**ECONOMIC COMMISSION FOR EUROPE  
INLAND TRANSPORT COMMITTEE  
World Forum for Harmonization of Vehicle Regulations (WP.29)  
Working Party on General Safety Provisions (GRSG)**

PROPOSAL FOR DRAFT AMENDMENTS TO REGULATION No. 107

Transmitted by the Expert from Germany

TRANS/WP.29/GRSG/2003/21/Rev. 1

Figure 11b

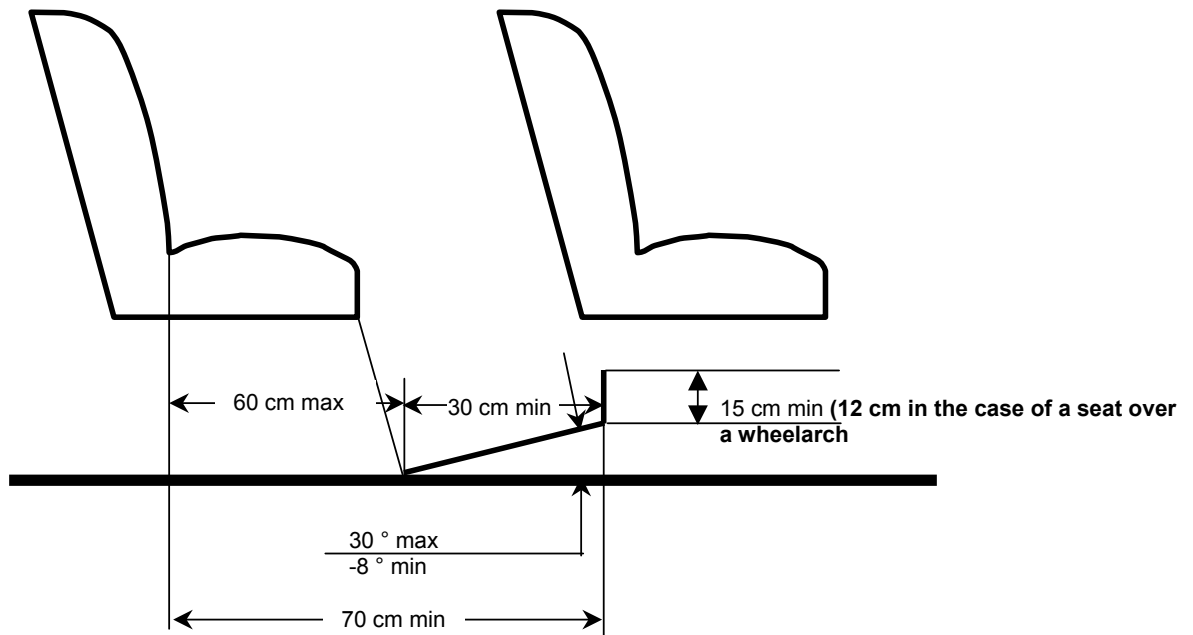
"5.7.9.5.2. For a seat behind a seat and/or a seat facing the gangway, a minimum clear foot space of at least 300 mm depth and a width according to paragraph 7.7.8.1.1. shall be provided as shown in annex 4, figure 11b. The local presence in this space of seat legs, **passenger footrests** and of intrusions as provided by paragraph 5.7.9.6.2.3 shall be permitted provided that adequate space remains for the passengers' feet. This foot space may partly be situated in and/or above the gangway but shall not create any obstruction when measuring the minimum gangway-width in accordance with paragraph 5.7.5. "

The intention of the proposal is to clarify that the foot space in front of a passenger seat may be restricted by passenger footrests and wheelarches.
